Technical Service Bulletin: TSB210002

New Thermocouple Exhaust Gas Temperature Sensor (EGTS) Introduction

Figure 1, Left: New Thermocouple EGTS. Right: Existing Thermistor EGTS.

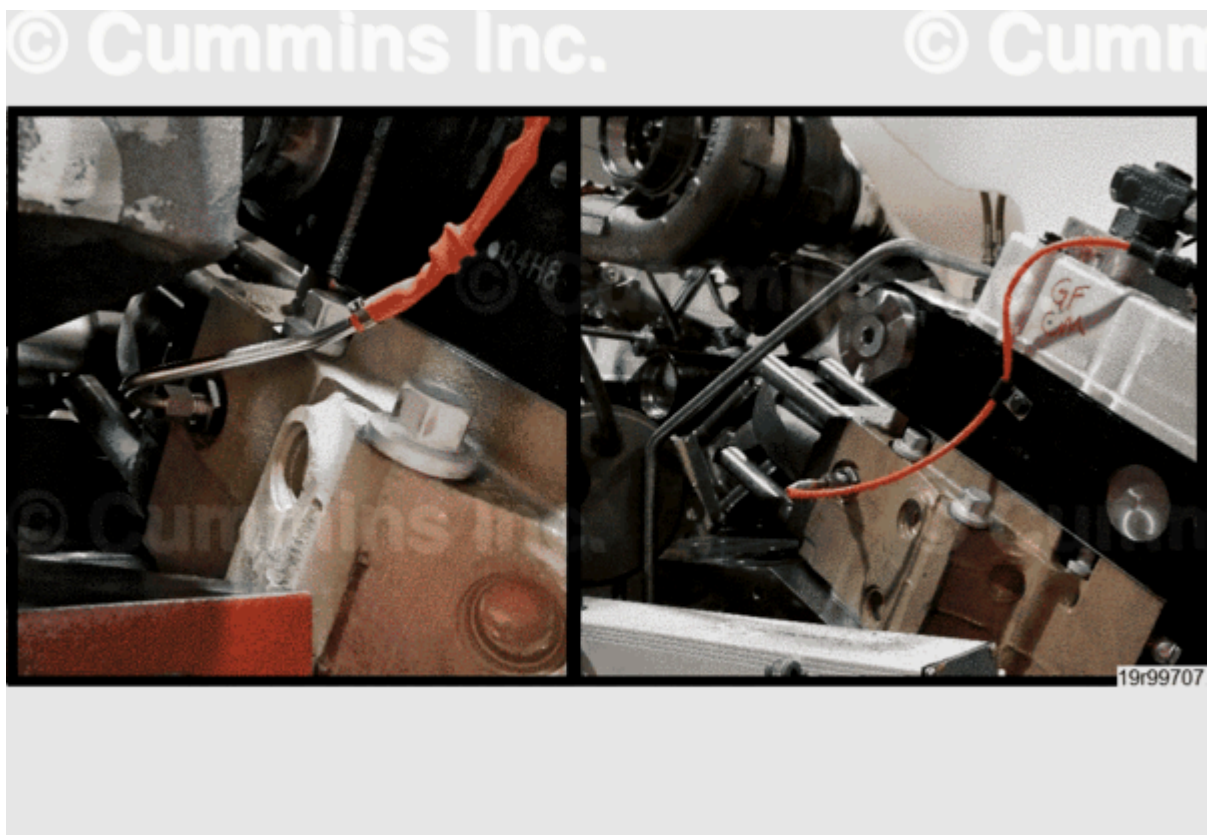
- Internal EGTS damage that is **not** visually detectable. Fracture of the EGTS's platinum rhodium wire. Thermistor EGTS are unable to withstand vibrations experienced during normal engine operation.

The new thermocouple EGTS are a “fish-hook” design which also mounts in each of the cylinder heads and have dark orange cables.

Figure 2, New Converter Box.

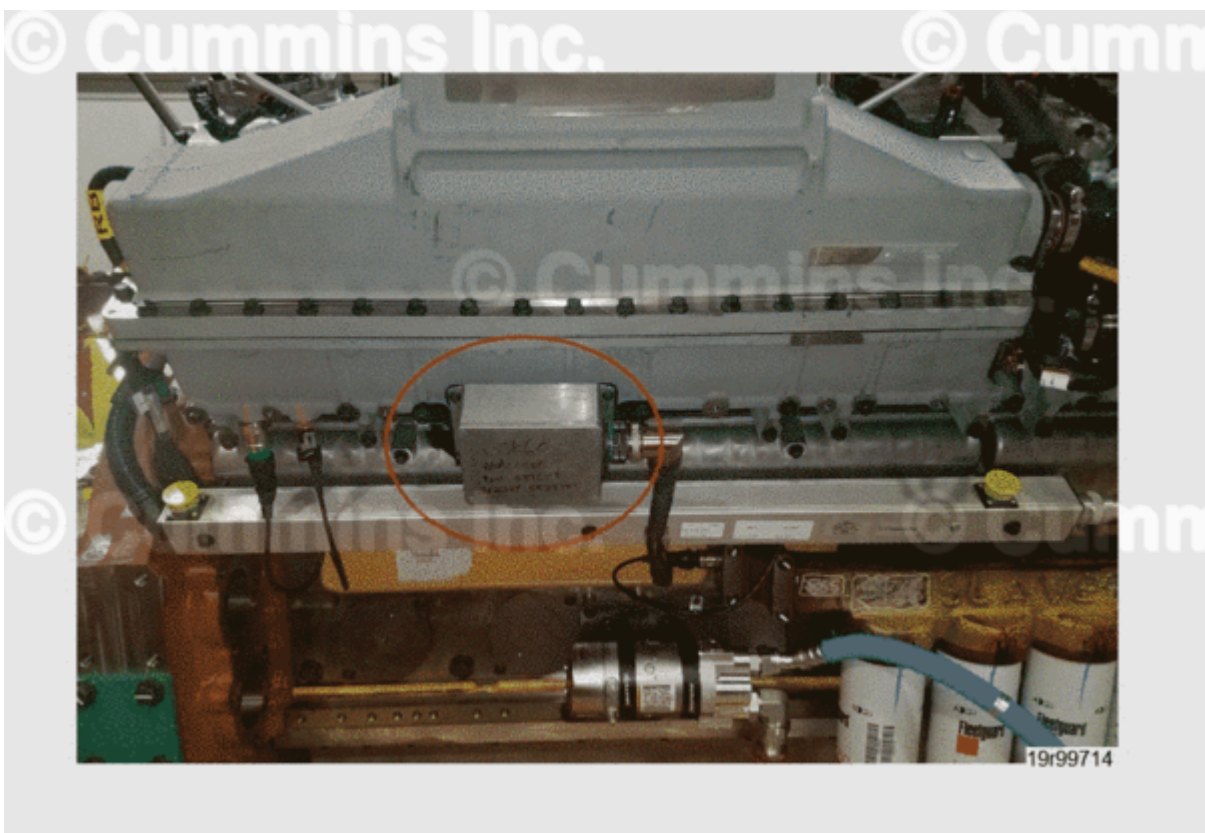
The main engine wiring harnesses now have an additional converter box connector breakout. This can be found on both the Left Bank (LB) and Right Bank (RB) main engine wiring harnesses.

Figure 4, Converter Box Mounted to Air Intake Manifold.

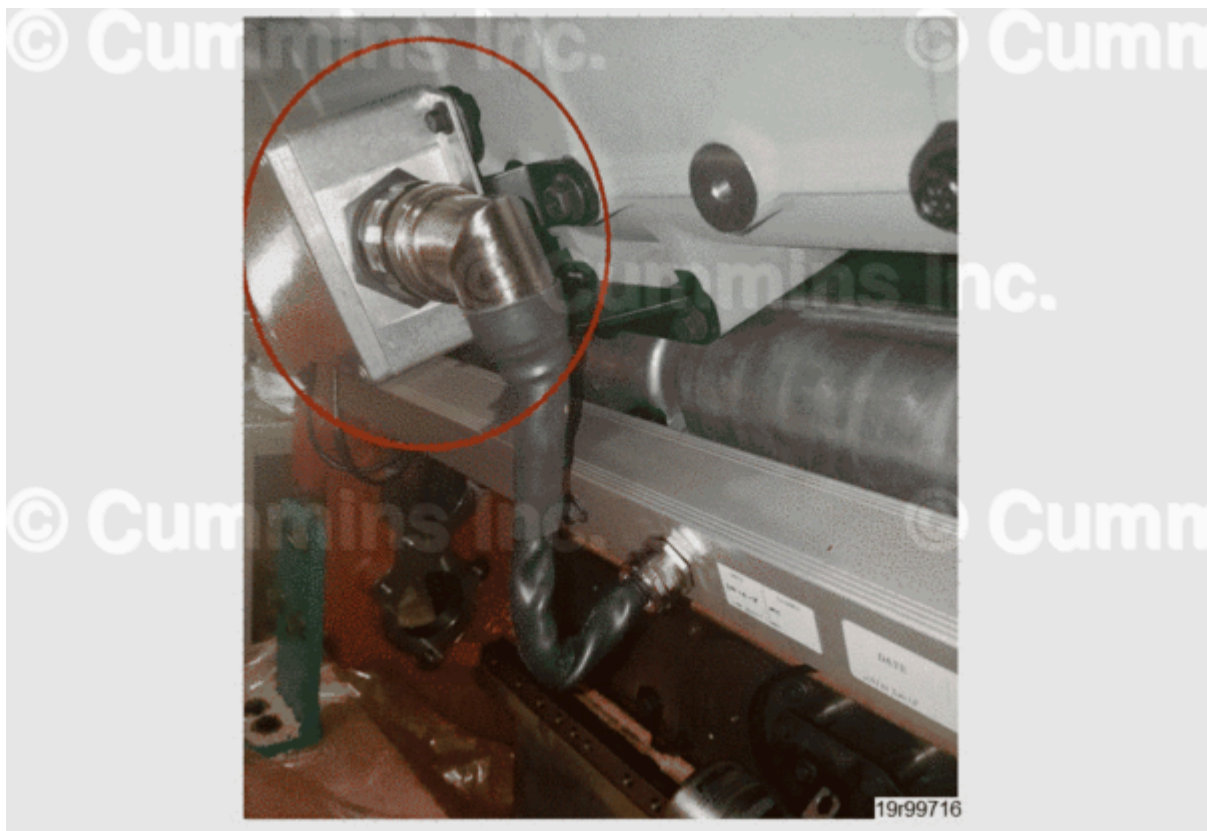
Two converter boxes are required to house and protect the internal signal conversion modules. The internal signal conversion modules process the thermocouple EGTS's signals for the engine's ECMs. Both LB and RB converter boxes are mounted on the air intake manifold of the engine.
